City of Arkadelphia
Planning Commission Meeting
June 10, 2021 at 5:30 p.m.
City Hall Boardroom, 700 Clay Street
Arkadelphia, Arkansas 71923

AGENDA

4. Consider Billy Bunn's request for a preliminary plat approval for Phase III of The Gardens Planned Unit Development near Walnut & Evonshire Streets.

5. Staff report for Good Ole Boys Holding Co., LLC's request for a revised preliminary plat approval.
6. Consider Good Ole Boys Holding Company, LLC's request for a revised preliminary plat approval for Phase I of Northridge Estates.

THE GARDENS A NEW RETIREMENT COMMUNITY IN ARKADIELPHIA, AR		PROJECT NAME	PROJECT NUMBER	DATE
SHEET NUMBER		DATE	DATE	DATE
S-1		DATE	DATE	DATE

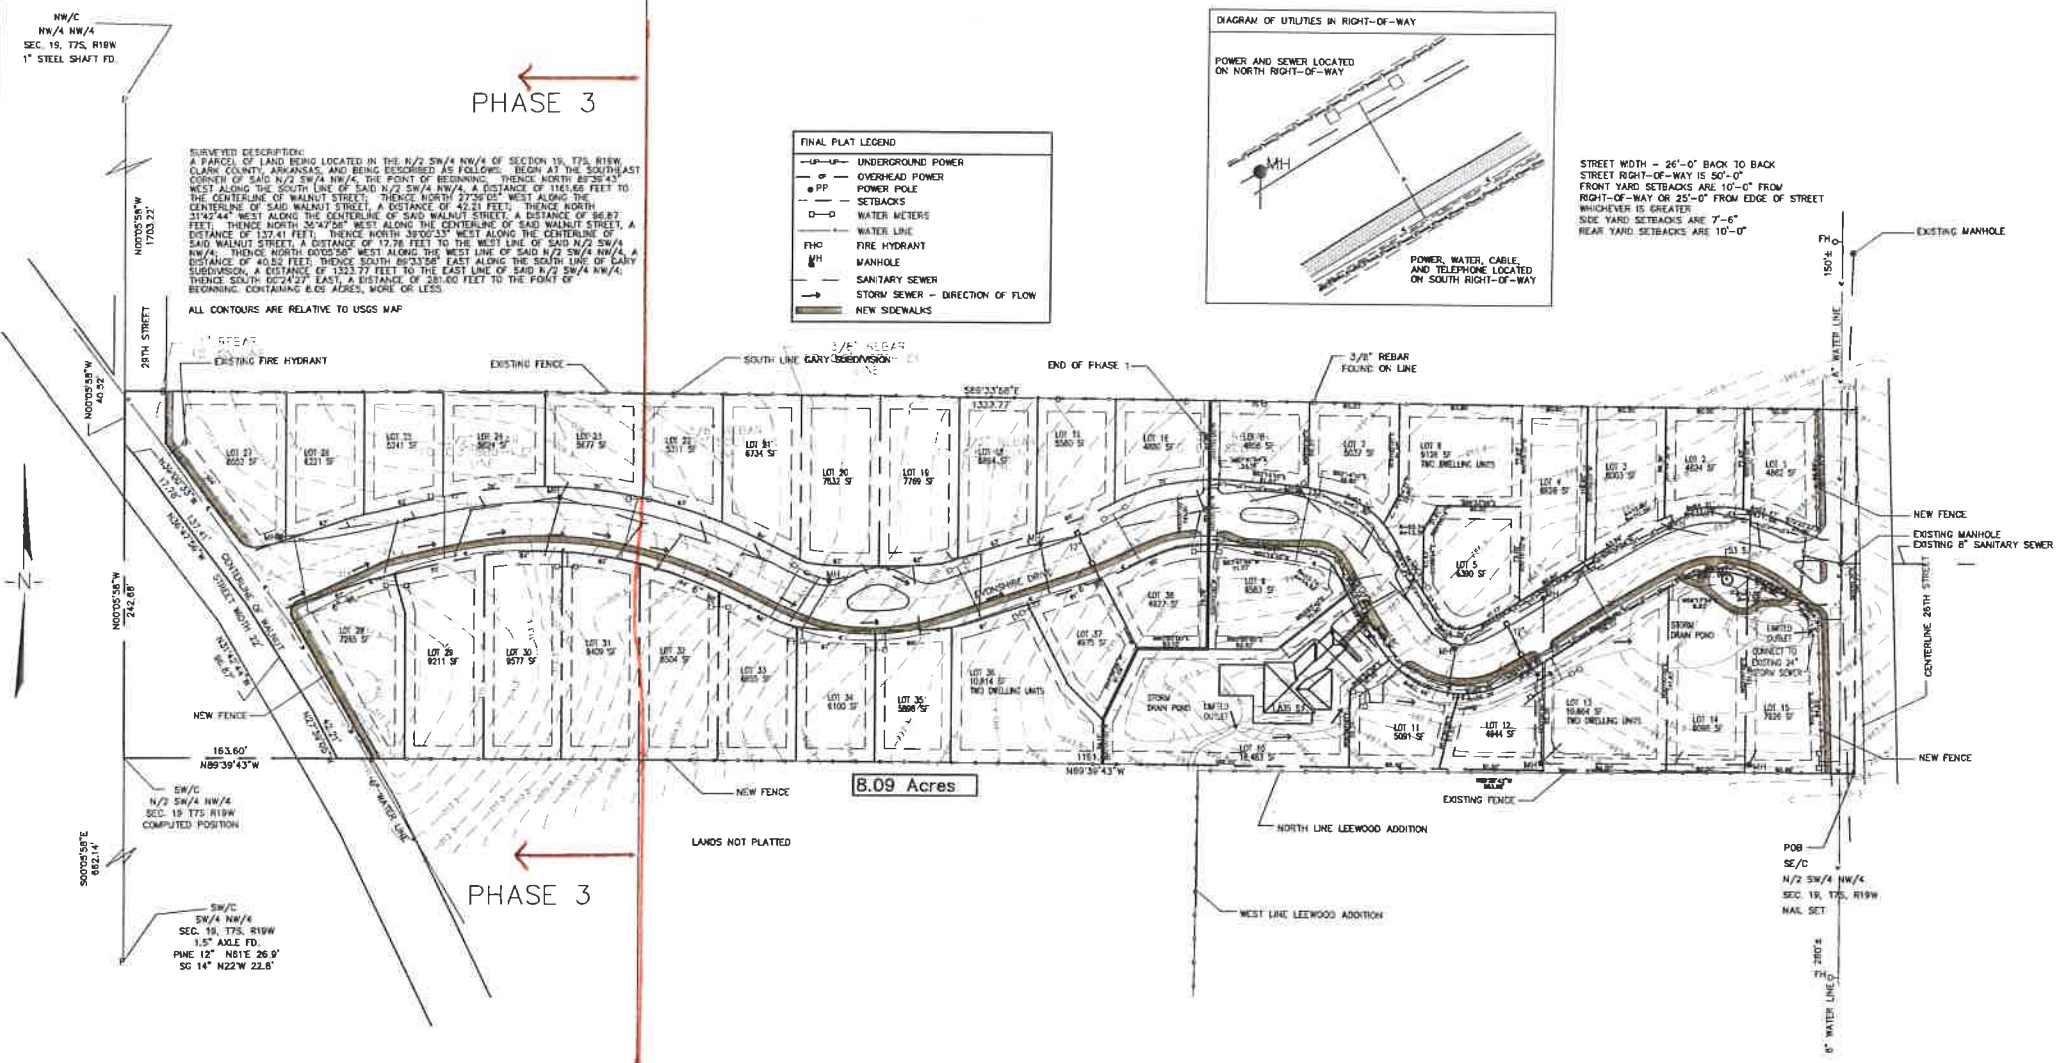
According to the minimum required improvements for subdivisions, the Planning Commission may make exceptions upon request of the subdivider. The applicant wishes to continue the 26-foot pavement width along Evonshire Drive and continue the sidewalk on the south side of the street. The minimum paved width for a local street is 27 feet from back of curb to back of curb. The Planning commission granted this exception for Phase I and Phase II.

1. Structure coverage in an R-1 district is not to exceed thirty-five percent of the total area of such lot. Applicant proposes to meet the minimum yard requirements (setbacks and separation distances) and parking requirements in lieu of this coverage requirement.

Staff recommends approving the preliminary plat/planned unit development proposal as submitted with exceptions and other matters as noted.

PRELIMINARY PLAT
NORTHTRIDGE ESTATES

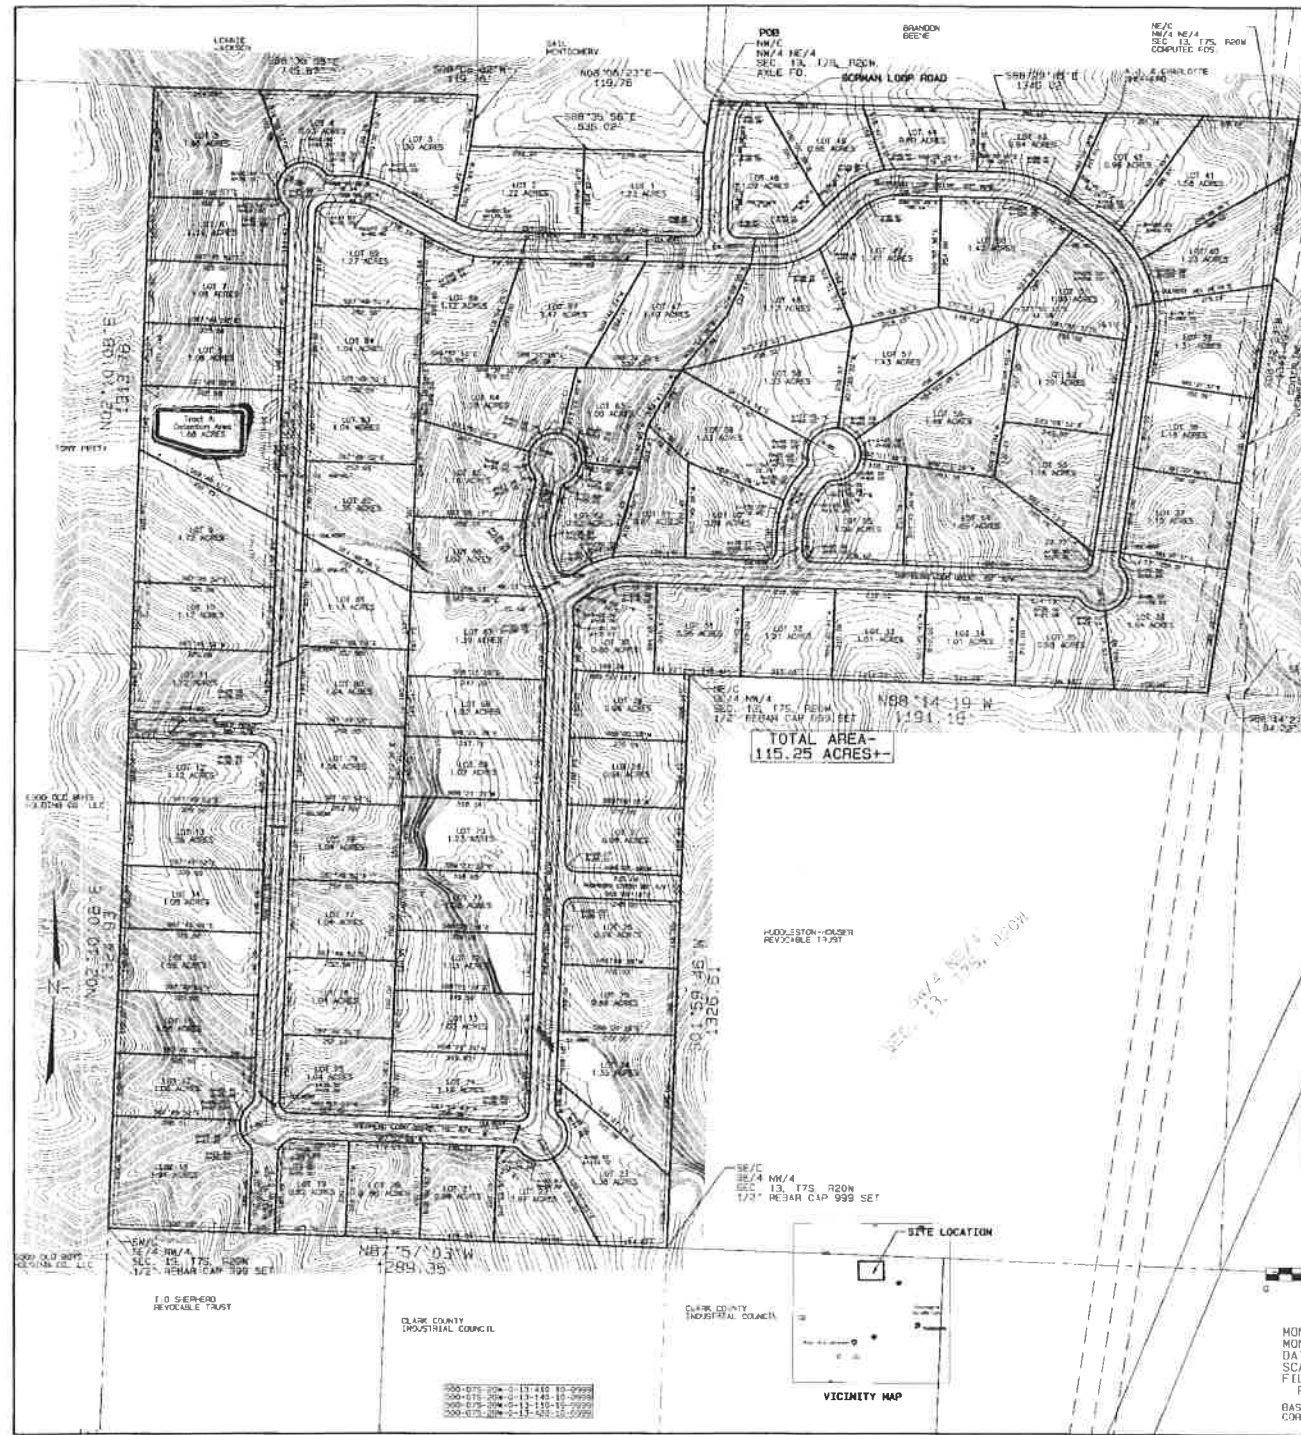
Northridge Estates' revised preliminary plat changes consist of the following:

- Reduced the number of lots from 88 to 87
- The relocation of two street entrances
- Renumbered the lots due to street entrances relocated.

According to the minimum required improvements for subdivisions, the Planning Commission may make exceptions upon request of the subdivider. *The owner wishes to continue the waiver of the required curbs, gutters and sidewalks, and approval contingent on the Bill of Assurance being provided, meeting all the criteria of the current Arkadelphia building regulations, the water and sewer system being approved by the Arkadelphia Water Department and the road designs are to Arkadelphia Street standards.* The minimum paved width for a local street is 27 feet from back of curb to back of curb. *The pavement width will be 20-foot with the right-of-way being 60-foot as approved on original preliminary plat.*

Staff recommends approving the revised preliminary plat proposal as submitted.

SITE PLAN
(BIDDING OPTIONS)

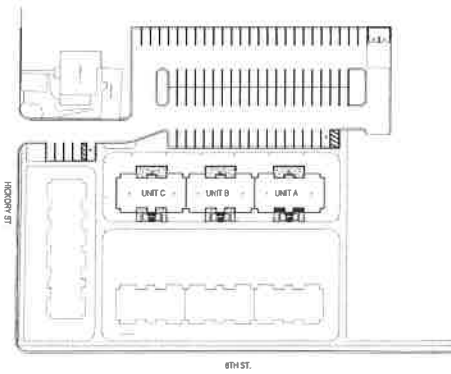
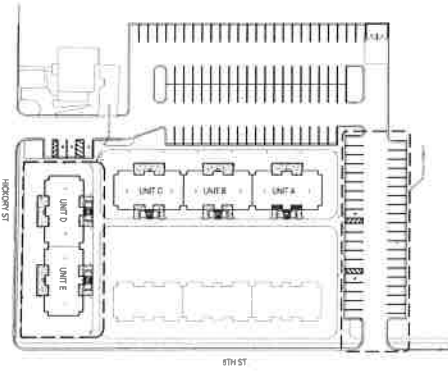
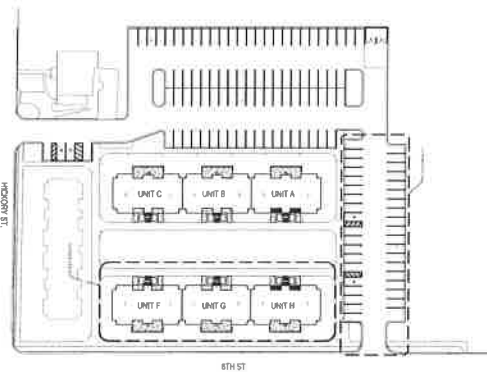
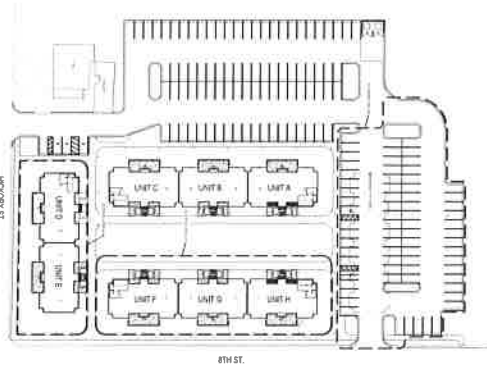
- Front yard – minimum 25 feet from property line or 50 feet from centerline of street
- Side yard – minimum 25 feet from street with interior side yards having a depth equal to the height of adjacent buildings which is 39'4"
 - Proposed side yard from 8th Street on Units D & E is 22'6";
 - Proposed interior side yard from Units D to C and E to F is 30' per plan

- Rear yard – minimum 25 feet
 - Proposed rear yard on 8th Street – 17'2"
 - Proposed Hickory Street – 20'

- Parking Lot Ordinance – 3 spaces per dwelling
- Building Proposal – each unit contains 6 apartments with 4 beds = 24 beds;
- Phase 1 has 3 units x 24 beds = 72 beds.
 - Proposed 18 apartments x 3 spaces = 54; proposed 89 parking spaces
- Phase Alt 1 has 5 units x 24 beds = 120 beds.
 - Proposed 30 apartments x 3 spaces = 90 ; proposed 127 parking spaces
- Phase Alt 2 has 6 units x 24 beds = 144 beds.
 - Proposed 36 apartments x 3 spaces = 108; proposed 127 parking spaces
- Phase Alt 3 has 8 units x 24 beds = 192 beds.
 - Proposed 48 apartments x 3 spaces = 144; proposed 154 parking spaces

Proposed parking exceeds the parking spaces required per Ordinance # O-97-8 but does not address number of beds nor any overflow parking due to visitation of occupants.

- Design does not allow a parking space for each bed – where will the overflow park if exceeds parking available?

Subdivision Regulations required parking space size is 9' x 20'

- Proposed parking space size is 9' x 18'

Staff has reviewed the proposed building plans and found them in substantial compliance with city requirements. The design is forward thinking and exactly what we need to create a better community in Arkadelphia. Staff is concerned with the size and number of parking spaces as proposed unless there is an alternate parking lot that is currently underutilized.

Staff recommends your approval of the plans to construct multiple student apartments in the Hardy and Barkman Addition located in all of Block 3, 10, part of Block 4, 9, 15, 16 and part of a closed street known as McMillian, contingent on N 9th Street being vacated by the City Board; the properties being rezoned from Multi-Family Residential (R-3) to Educational District (E-1) and with any conditions you deem appropriate. The motion should also contain the statement, with the condition Ouachita Baptist University comply with all applicable Arkadelphia regulations, including but not limited to Dumpster Pad Ordinance O-16-19, Floodplain Ordinance O-04-10 and the Erosion and Sediment Control Ordinance O-21-02.
